WENATCHEE HISTORIC PRESERVATION BOARD REGULAR MEETING September 6, 2023

STAFF REPORT HP-23-04, 30 S. MILLER STREET

Description of Request: This is an application that seeks to obtain a certificate of appropriateness for modifications made to the front porch steps that are part of the entrance portico. The building is listed on the Wenatchee Register of Historic Places.

Description of Request: This is an application for a Certificate of Appropriateness for exterior modifications to 500 King Street within the Grandview Historic District. The property is identified as contributing to the district. The application proposes the following changes to the exterior, visible from the public street:

After modifications made to steps

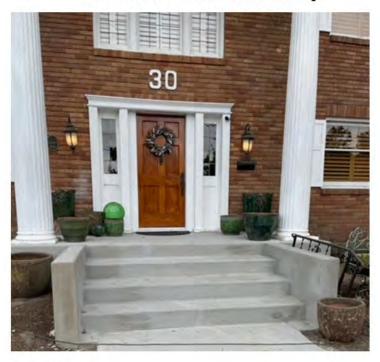
Staff Analysis: The standards that apply to the reconstruction of a portion of the front porch and the associated steps include (i), (ii), (iii), (v), (vi), and (ix).

The application narrative states that the front porch was structurally compromised and replaced to protect the two-story wood Doric columns that support to portico, a significant historic feature of the home. The alteration to the porch front and steps is consistent with standards identified as applicable to this project.

The standards in general seek that historic material is not altered, unless necessary to support continued use and significant features of the structure. The house was originally built as a single-family home and is continuing the use. The front porch and portico are identified significant features of the home and this work will maintain and continue the use and form.

The applicant has taken care to replace the porch and step configuration in the same footprint and use concrete, the same material as the original steps. The smooth of the concrete was sacked to recreate the smooth finish of the original steps.

The design of the porch and steps was altered from the original in that the concrete overhang over the foundation of the porch and step walls. The applicant states that this design choice was made to minimize future damage and alteration to other historic features.

The application for reconstruction of the deteriorated portions of the porch and steps for the portico were necessary work for the maintenance of the portico which is a significant feature of the building.

1. The project application shall proceed consistent with this staff report and the plans submitted on July 25, 2023 as attached to the staff report dated August 30, 2023,

- except as conditioned below. The removal or alteration of any other historic material or distinctive architectural features must be avoided.
- 2. Any work beyond the scope of this Certificate of Appropriateness shall be reviewed by staff to determine its effect on the historic features of the structure. If staff determines that the new work affects historic features in a manner not approved (such as replacement of features not currently proposed), then an amendment to this certificate shall be obtained prior to resuming work.
- 3. Within 30 days of completion of work, the applicant shall provide pictures that document the work in compliance with this approved Certificate of Appropriateness.

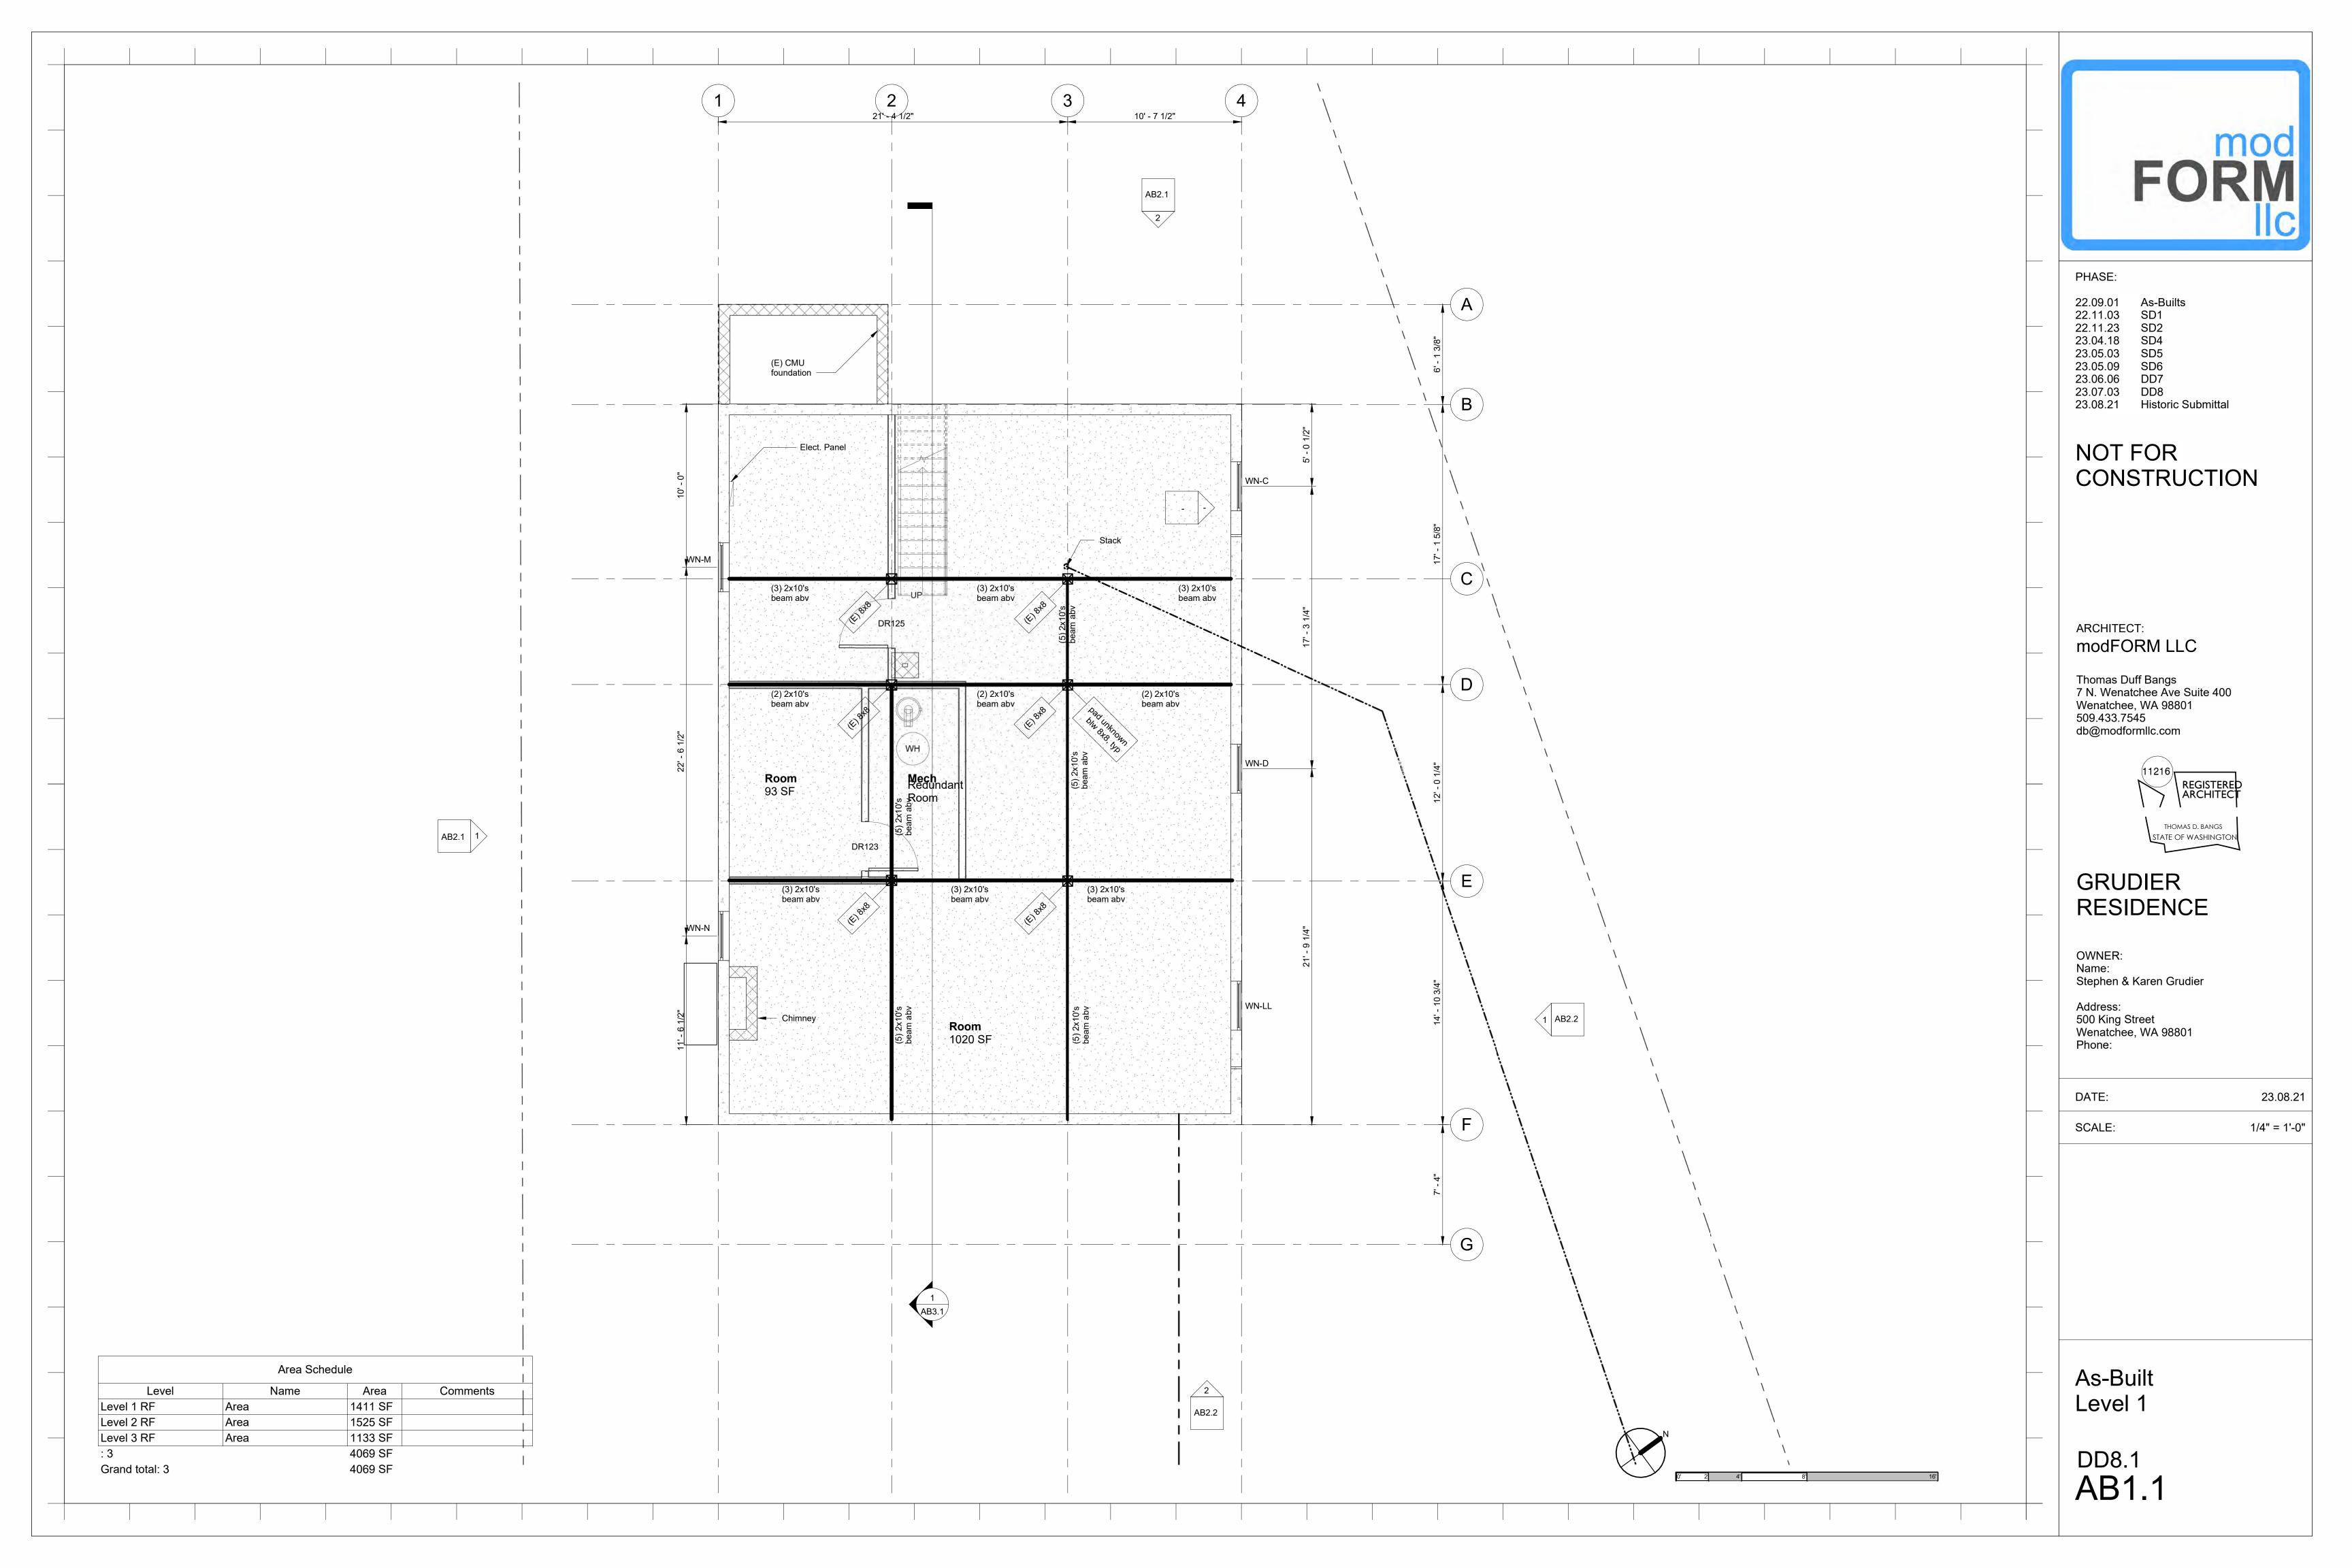
Staff Analysis: The front porch is in poor condition and the applicant is proposing to remove and rebuild the porch in the exact location and configuration utilizing the original bricks.

The front porch will be carefully demolished to save the original brick. It will then be rebuilt with more modern structural requirements. The original design will be used to reconstruct. New concrete caps will be installed on the porch walls along with new concrete steps.
